CITY PLAN COMMISSION STAFF REPORT

Project Name
City Harvest

CD-CPC-2022-00174
Rezoning from district UR to district UR Development Plan

CITY HARVEST UR PLAN AND PRELIMINARY PLAT

EXTERIOR ELEVATIONS

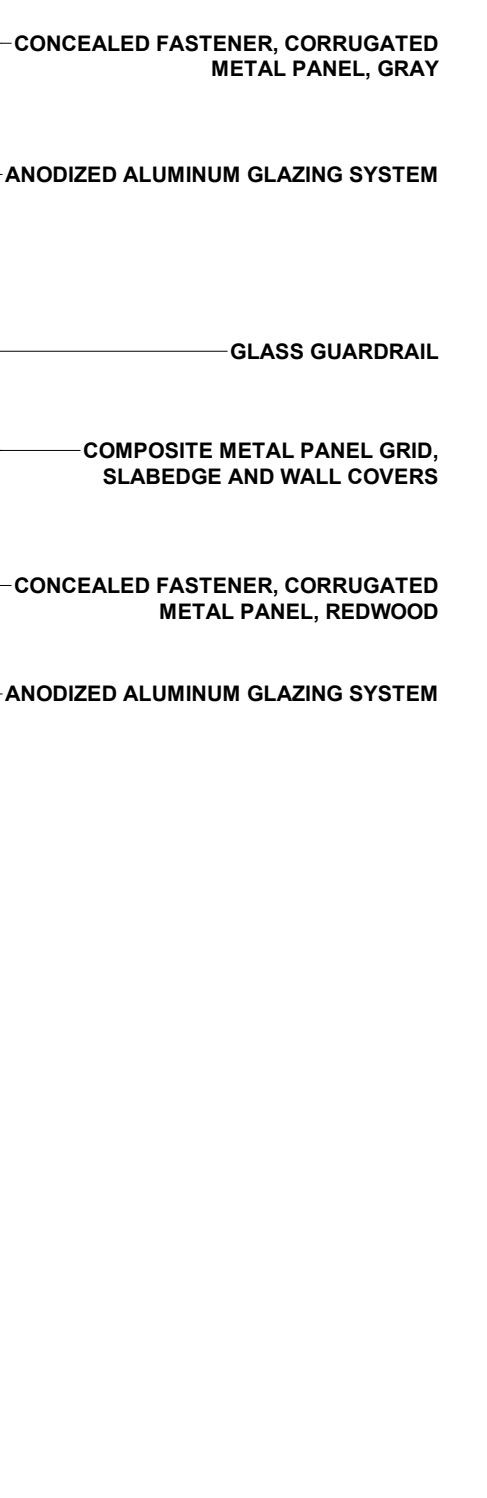
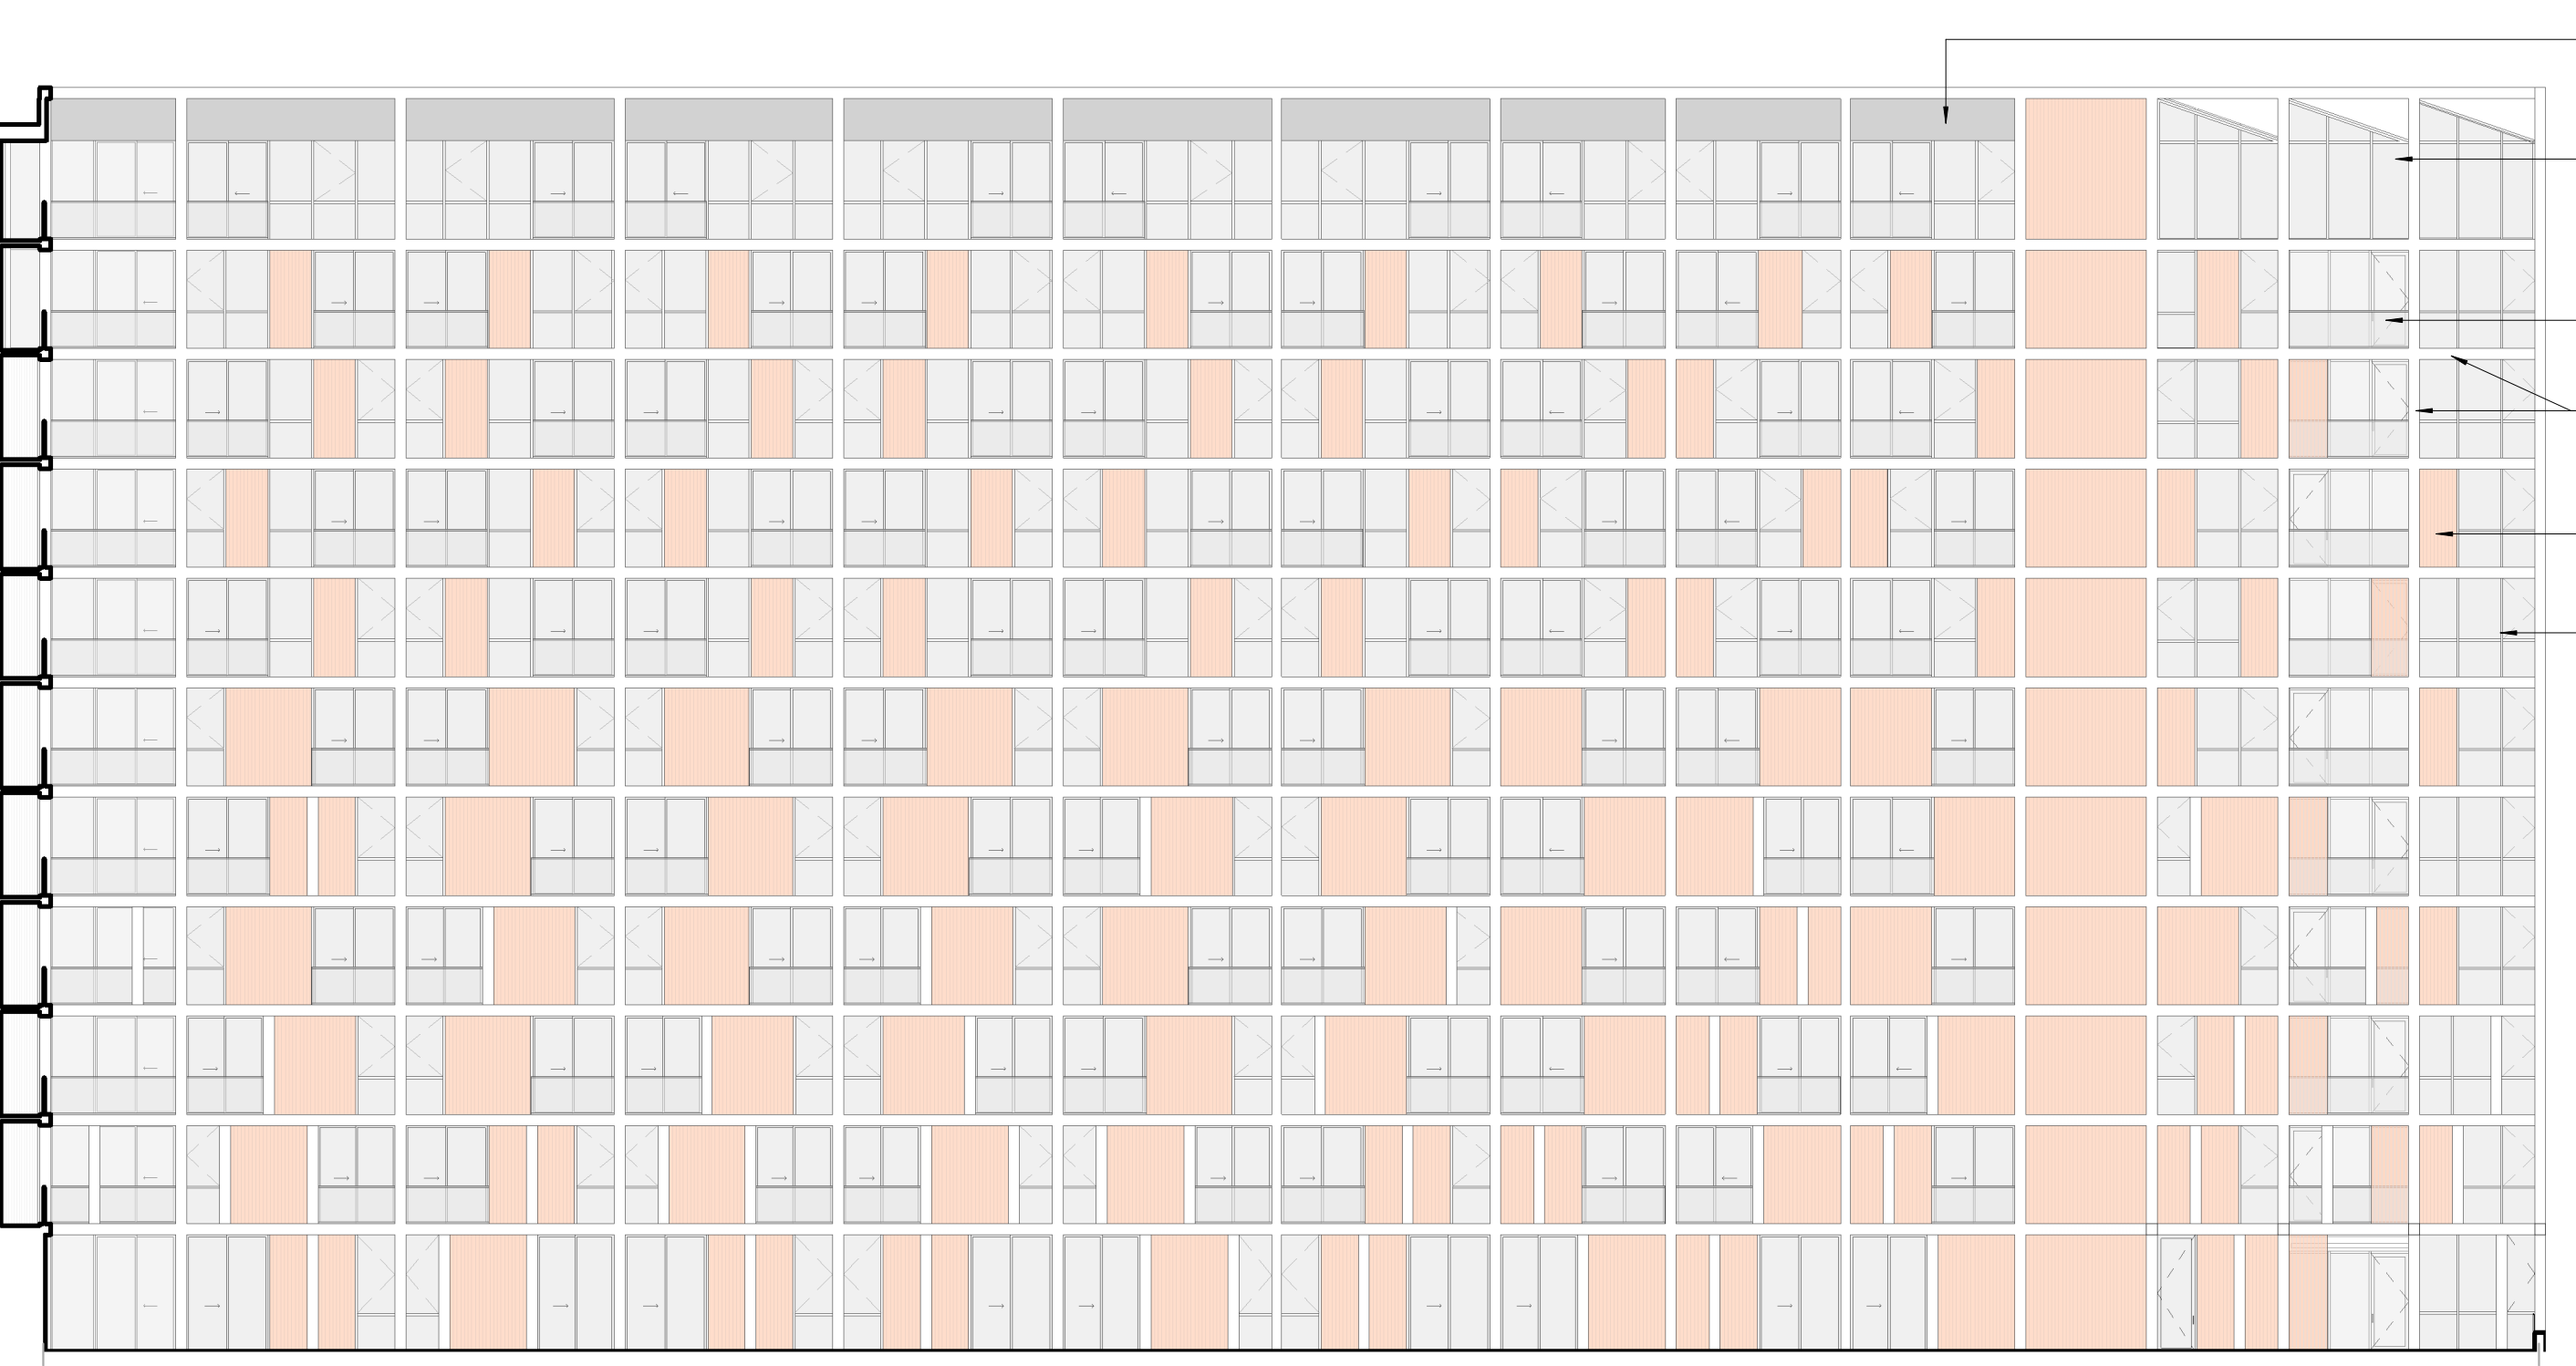
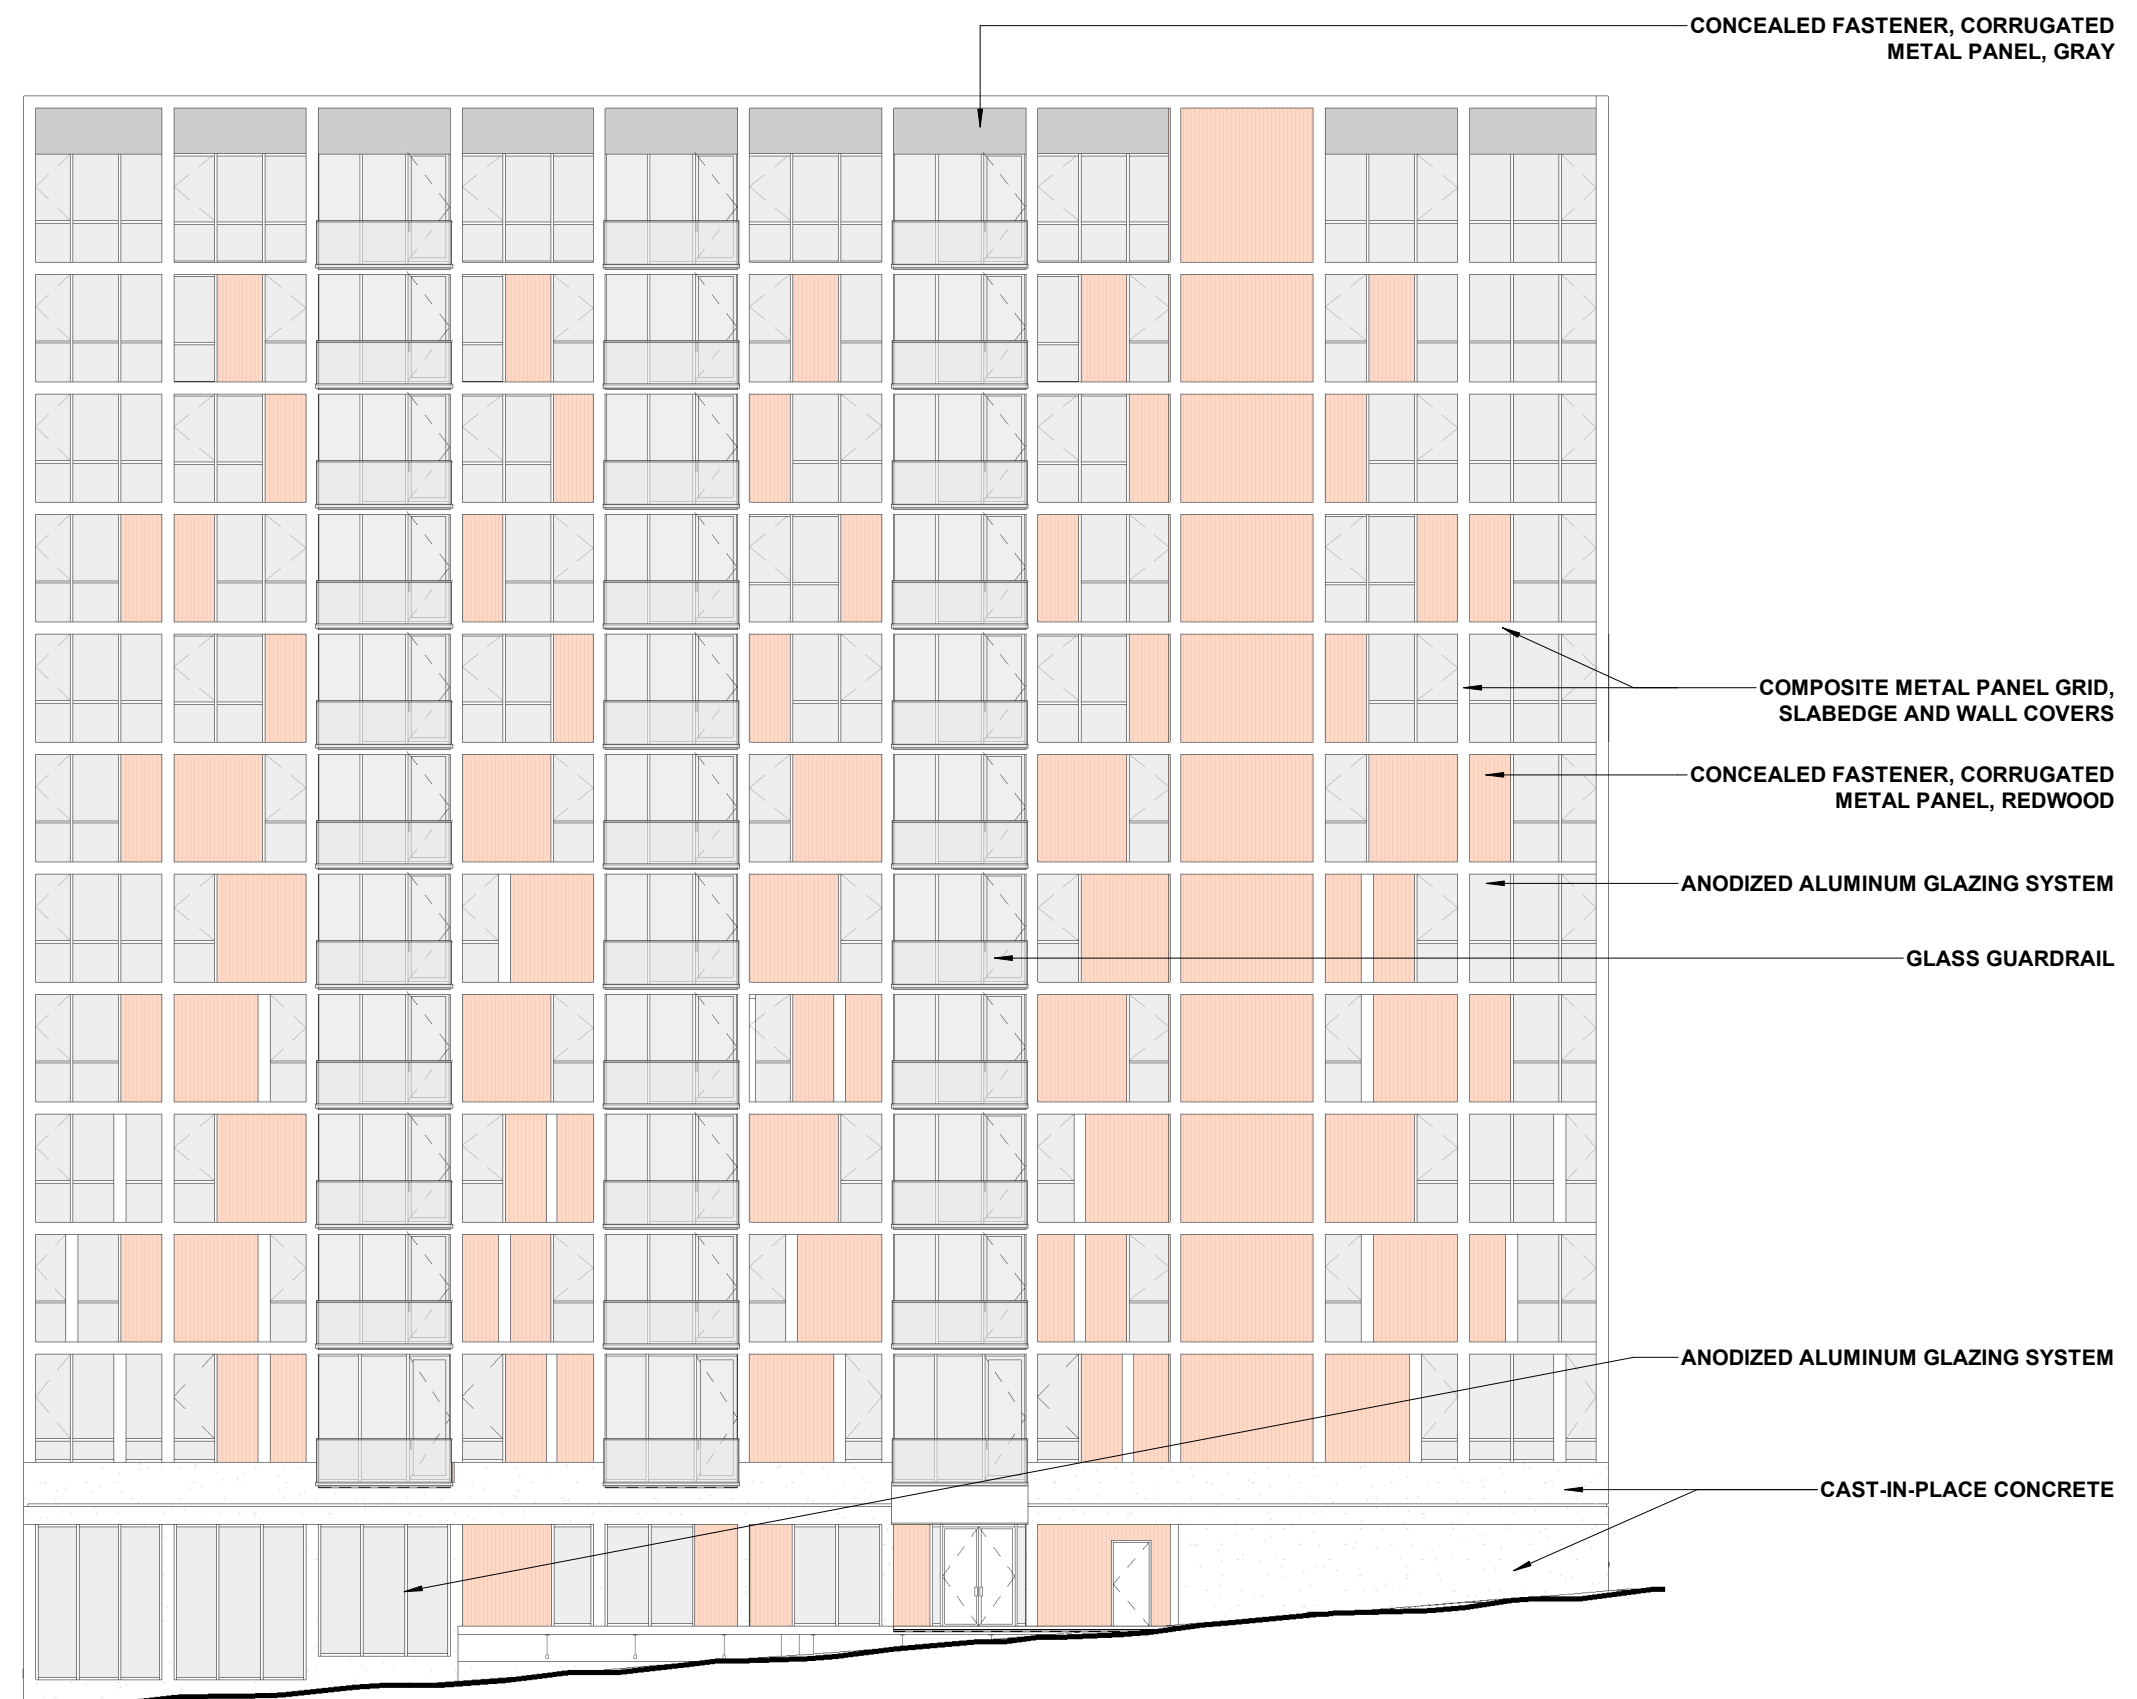
The proposed structure has a large amount of concrete on the east, west, and north elevations. The developer will need to work with staff to find appropriate alternatives for the blank spaces such as differing construction materials or public art installations at the time of UR Final Plan.

15. The developer shall continue to work with Staff to provide alternatives to the vast areas of blank concrete proposed for the first couple floors of the building. Alternatives shall be submitted at the time of UR Final Plan submittal.
